**STAFF REPORT
GREENFIELD PLAN COMMISSION
TUESDAY, JULY 10, 2018
6:30 PM**

ROOM 100 – CITY HALL – 7325 W. FOREST HOME AVE., GREENFIELD, WI 53220

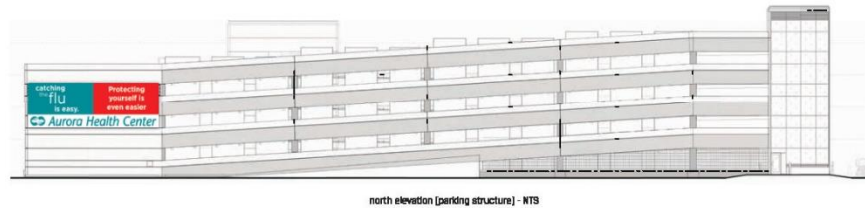
Staff does not recommend approval of the large electronic display sign on the north side of the parking structure, for safety and aesthetic purposes. The sign could easily become a distraction to drivers on the freeway, and would easily become a nuisance to the residential properties on the north side of I-894.

Recommendation: Approve the Master Signage Plan for Aurora Health Care, to be located within the 84 South Development at 8960 & 9000 Sura Ln., submitted by Deb Burton, d/b/a Poblocki Sign Company, LLC, not including the electronic message display sign. (Tax Key No. 606-9980-013)

6. Revised Site, Landscaping and Architectural Plans for Pearson Point, a proposed multi-family development, to be located at 11800 W. Beloit Rd., submitted by Raymond Chou, d/b/a Pearson Point, LLC. (Tax Key No. 565-9955-007)

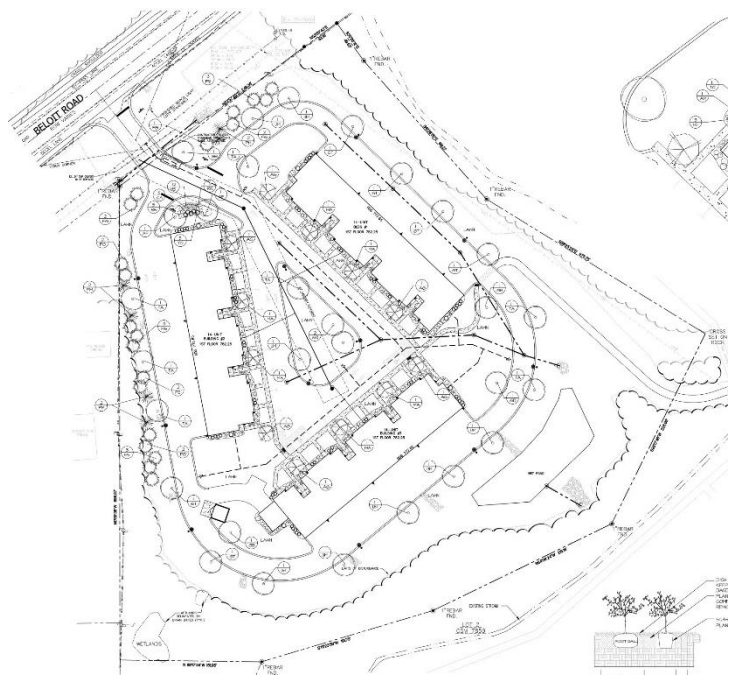
Mr. Chou's revised plans have reduced the number of units by six (6): two (2) per building. The general site layout and architectural elevations/building materials have not changed with the unit reduction.

With Plan Commission's recommendation, this item may be expedited to the July 17th Common Council meeting, where Common Council will again reconsider the site, landscaping, architectural plans, as well as the rezoning and land use amendment proposal. Staff's recommendations remain similar to those in February.

1. A revised Site, Landscaping and Architectural Plan being submitted to the Community Development Division to show the following: (a) accurate building material identifications; (b) colored light pole specifications; (c) an additional refuse enclosure at the northeast section of the site; (d) the WEPCO light fixture near W. Beloit Rd., to be of the same design as the on-site light fixtures; and, (e) any landscaping specie/quantity recommendations as provided by the City Forester.

2. A revised Site Plan and a Stormwater Management Plan showing modifications/requirements as directed by the Engineering Department's letter to the developer dated February 2, 2018, subject to change in order to meet Municipal Code requirements.

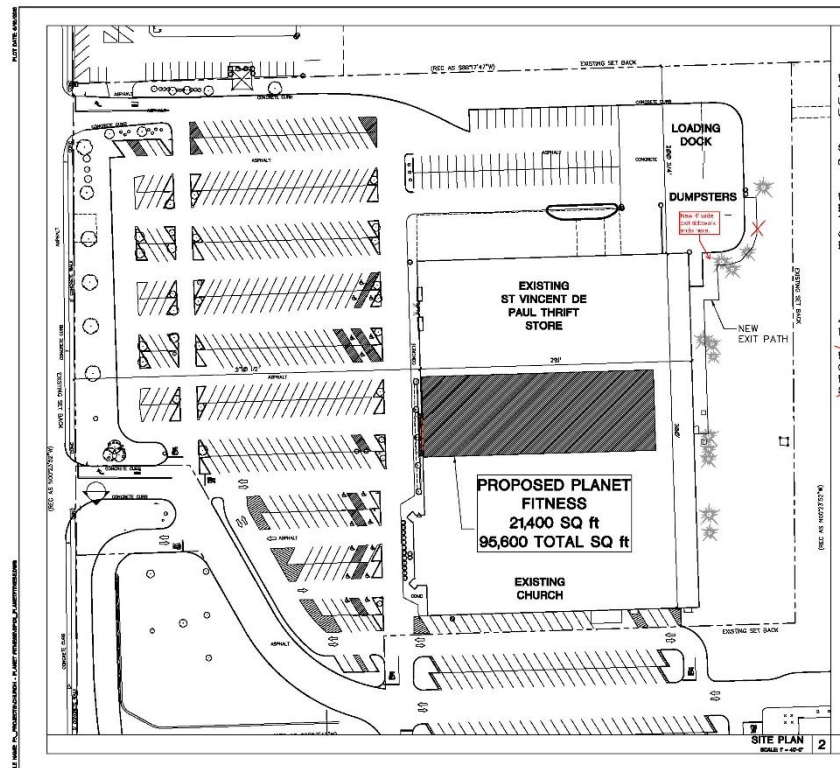
The applicant submitted an as-built site and landscaping plan for the entire Ridge Church property. The middle portion in front of the proposed Planet Fitness tenant was recently repaved. When visiting the site, staff noticed that all the trees in the landscape islands closest to Hwy 100 were dead. The City Forester noted that those were Ash trees, which need to be replaced with a different species and noted on revised plans.

When visiting the site, staff noticed remnant concrete bases along Hwy 100 of what likely used to be light poles. Revised plans should note the removal of any remnant concrete bases on site. Also, dumpsters are not located within a four-sided refuse enclosure. Staff recommends that a four-sided board-on-board with a personal door be constructed in the rear of the building to screen dumpsters.

1. A Site, Landscaping and Architectural Plans being submitted to the Community Development Division to show the following: (a) tree replacement of any dead trees on the property, species to be approved by the City Forester; (b) notation of removal of remnant concrete light pole bases; (c) reduction of purple-colored EIFS to the rectangle sign portion of the front façade; (e) scoring of EIFS on the front façade; (f) the metal canopy being painted a natural color, not yellow; (g) accurate notation of sidewalk locations in the rear of the building; and, (h) the construction of a four-sided board-on-board refuse enclosure with a personal door in the northeast portion of the property.

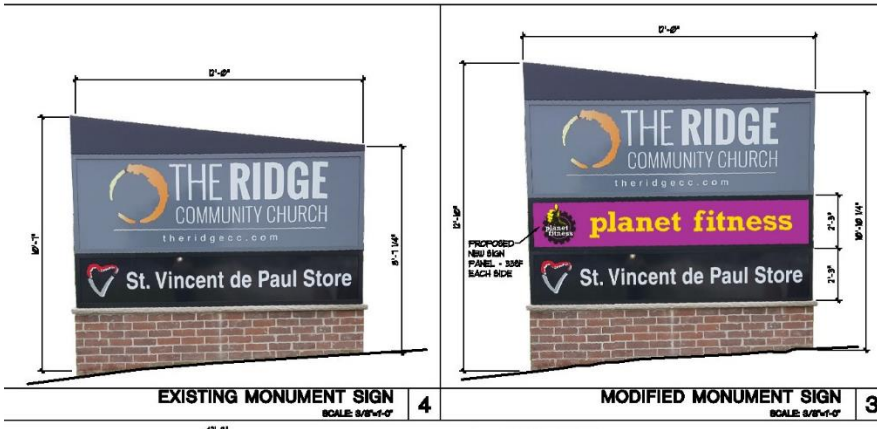
Staff is recommending to limit the purple to the rectangle behind the signage area and to add decorative scoring in the EIFS to give the upper portion of the façade some architectural relief. Staff is also recommending that the metal canopy be grey or taupe in color, rather than the proposed yellow.

BUILDING ADDITION FOR:
NOLAN ACCOUNTING
4203 SOUTH 108TH STREET
GREENFIELD, WI

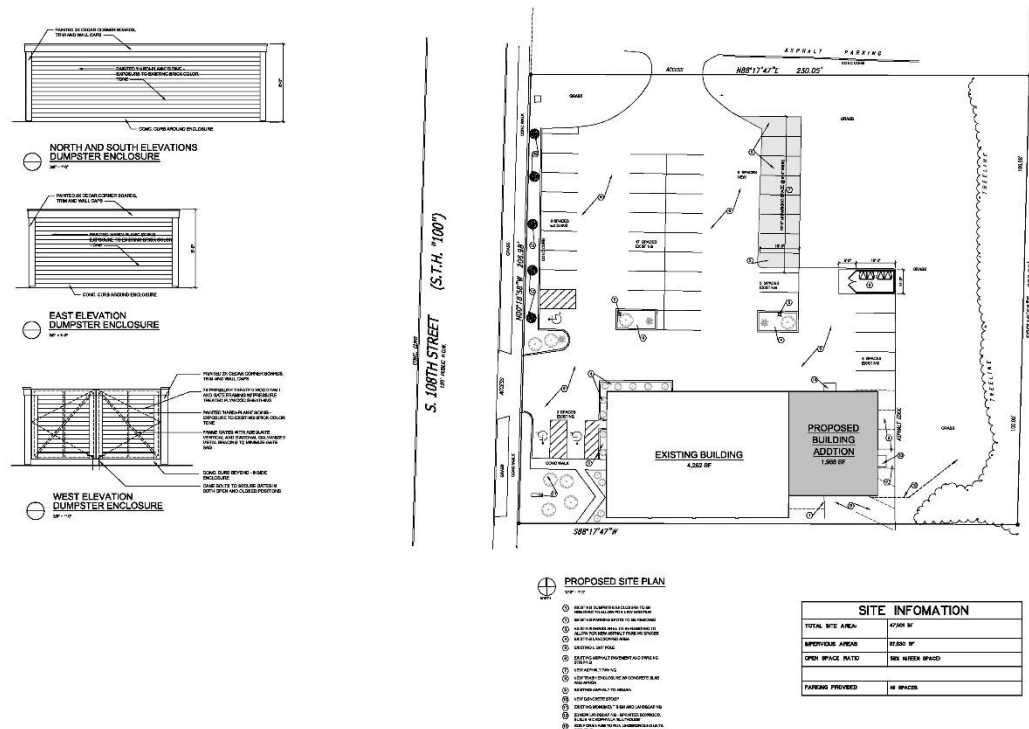
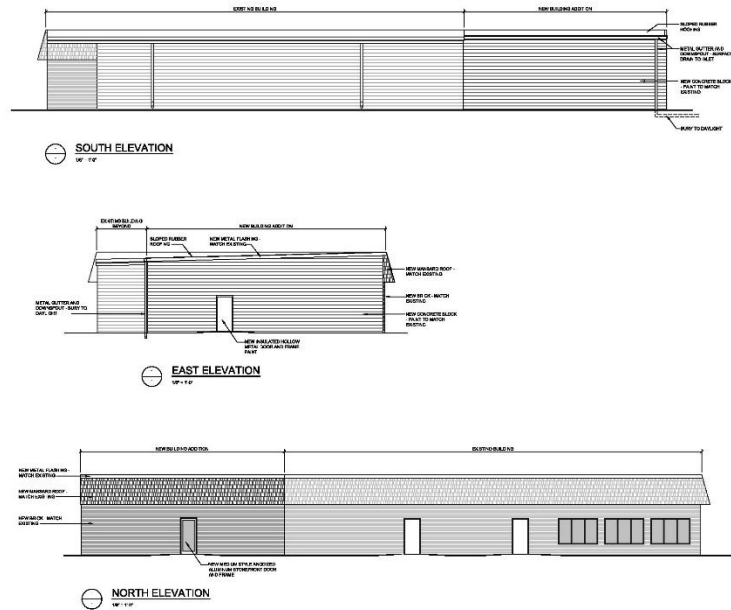
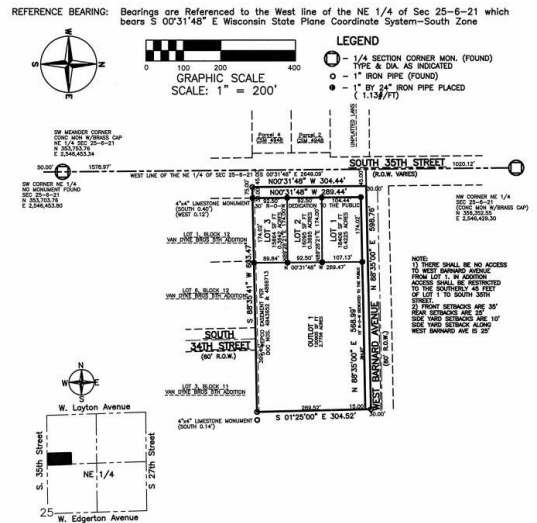
The proposal includes the installation of five (5) new Sprinter Boxwood shrubs along the west Hwy 100 property line and the construction of a new four-sided hardiplank refuse enclosure. Staff recommends that a personal door be added to the refuse enclosure design.

The design proposes to keep the existing asphalt in the southeast corner of the site, surrounding the addition. Staff recommends that in order to eliminate a potential outdoor storage issue, that that area be converted to grass. Staff has been informed that the property owner keeps a

trailer on site, which could simply be delineated on a revised site plan in a designated location.

1. Revised Site, Landscaping and Architectural Plans being submitted to the Community Development Division to show the following: (a) refuse enclosure including a personal door; (b) area around the building addition being converted to grass; and, (c) delineation of location for trailer storage.
2. A Certified Survey Map being submitted to the Community Development Division by September 13, 2018 for Plan Commission and Common Council review, for the combination of two (2) lots.

CERTIFIED SURVEY MAP NO. _____ PAGE 1 OF 3
 BEING A PART OF THE NORTHWEST QUARTER (NW 1/4) OF THE NORTHEAST QUARTER (NE 1/4) OF SECTION 25, TOWN 6 NORTH, RANGE 21 EAST, IN THE CITY OF GREENFIELD, MILWAUKEE COUNTY, WISCONSIN.

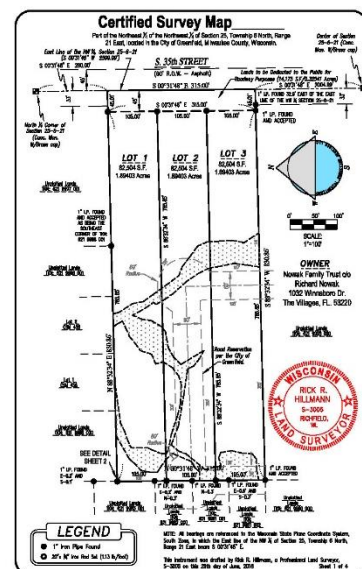
The Engineering Division staff has submitted comments to the surveyor, requesting editing modifications on the proposed CSM, including a 10-foot drainage easement along the south of Lot 3, which will be edited prior to recording of the CSM. The Engineering Division has commented that sanitary/storm/water laterals will be required to be installed up to the lot lines prior to recording of the CSM. In addition, a grading plan shall be submitted to the Engineering Division for review/approval prior to recording of the CSM, to ensure that future development of the lots will be graded appropriately. Staff recommends that this item be expedited to the July 17, 2018 Common Council meeting. The developer will be required to pay

1. A revised Certified Survey Map being submitted to the Engineering Division showing a 10-foot drainage easement along the south of Lot 3, in addition to any other comments the Engineering Division may have.
2. A grading plan being submitted to the Engineering Division for review and approval.
3. Installation of sanitary/storm/water laterals, subject to Engineering Division approval.
4. Payment of the City's impact fee of \$1,806 per new dwelling unit prior to recording of the CSM.

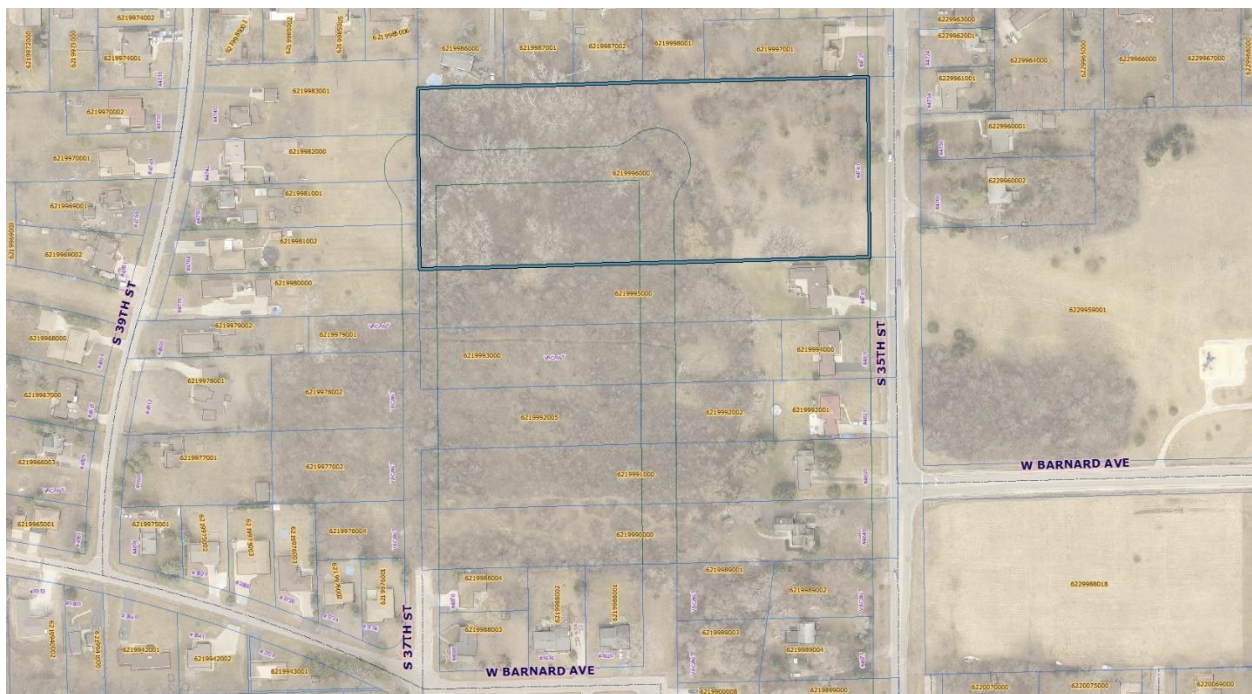
The Engineering Division staff has submitted comments to the surveyor, requesting editing modifications on the proposed CSM, including accurate wetland delineations, which will be edited prior to recording of the CSM. In addition, a grading plan shall be submitted to the Engineering Division for review/approval prior to recording of the CSM, to ensure that future development of the lots will be graded appropriately. Staff recommends that this item be expedited to the July 17, 2018 Common Council meeting.

1. A revised Certified Survey Map being submitted to the Engineering Division showing accurate wetland delineations, in addition to any other comments the Engineering Division may have.
2. A grading plan being submitted to the Engineering Division for review and approval.
3. Payment of the City's impact fee of \$1,806 per new dwelling unit prior to recording of the CSM.
